SERVICE BULLETIN

N° 189-303

**ATA 25 - EMERGENCY LIFE-RAFT SYSTEM, ONE-TIME UPGRADE FOR ACTUATION
PULLEYS INSTALLATION**

AERO SEKUR SERVICE BULLETIN SB-189-25-010

OLD	NEW

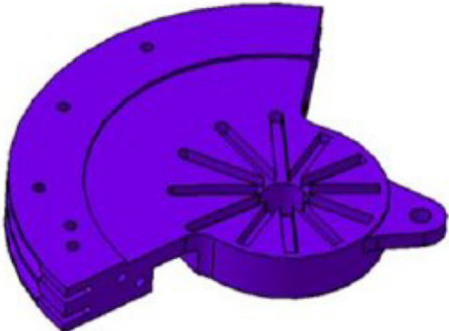
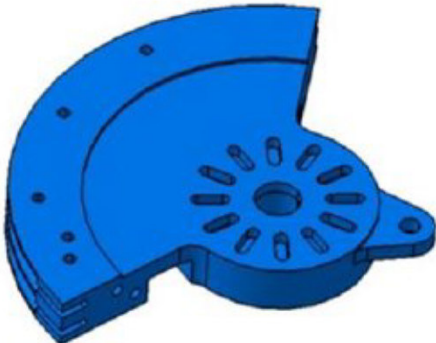
This Service Bulletin introduces the new configuration of actuation pulleys. The previous upper pulley P/N 309774A is a single component mounted specularly on both left-hand and right-hand for ELS installations; this can lead to an incorrect installation of it and special attention must be taken during assembly phase because its position on the Lower pulley varies for left-hand and right-hand installation. An improper installation of Upper pulley P/N 309774A and raft activation cable implies the incorrect functioning of the ELS in emergency condition.

This Service Bulletin provides a new P/Ns for an upgrade kit, containing the new configuration of Upper and Lower Pulleys, to be used to replace the ones for the earlier configuration:

<p style="text-align: right;">SYMMETRIC RIBS</p>	 <p style="text-align: right;">ASYMMETRIC RIBS</p>
Upper Pulley P/N 309774A rev.B	Upper Pulley P/N 309774B rev.A

Lower Pulleys: PN 309771A Rev D (left installation) PN 309877A Rev D (right installation)	Lower Pulleys: PN 309771B Rev A (left installation) PN 309877B Rev A (right installation)

Figure 3 – Raft actuation cable release / locking

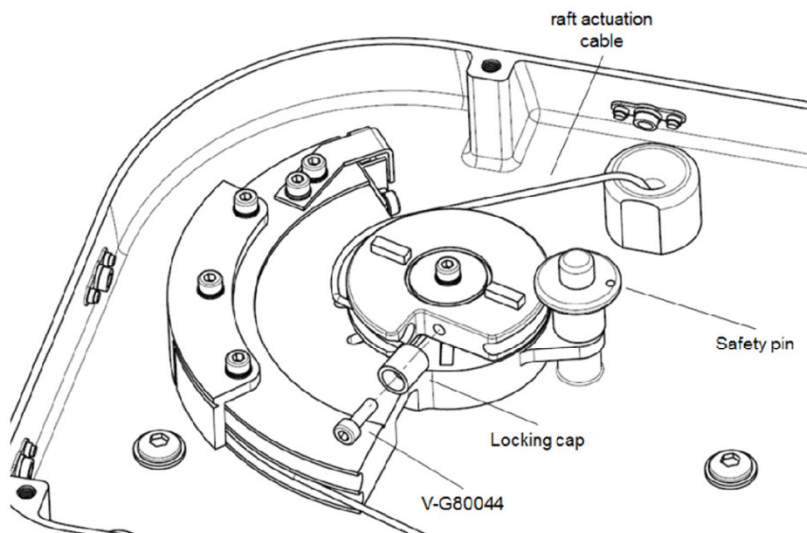
- (b) Remove the Locking cap P/N 309807A unscrewing the screw P/N V-G80044 and release the raft actuation cable from the Upper Pulley P/N 309774A. Ref to Figure 3.

Figure 4 – Upper Pulley disassembly / assembly

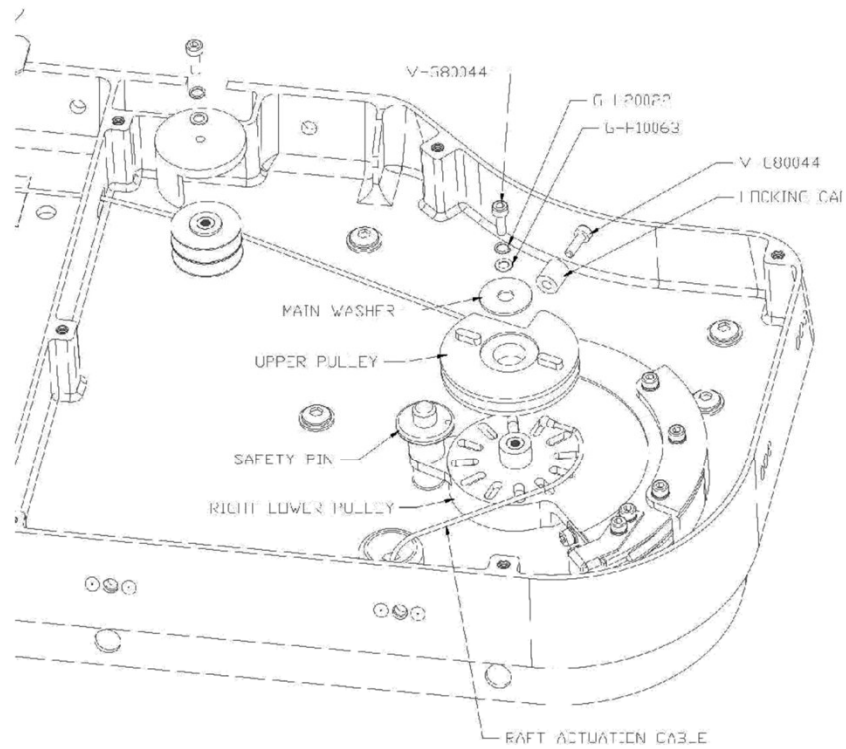
- (c) Remove the Main Washer P/N 309773A from the Upper Pulley P/N 309774A unscrewing the screws P/N V-G80044, with the grower P/N G-H20022 and the washers P/N G-H10063, ref. to Figure 4.
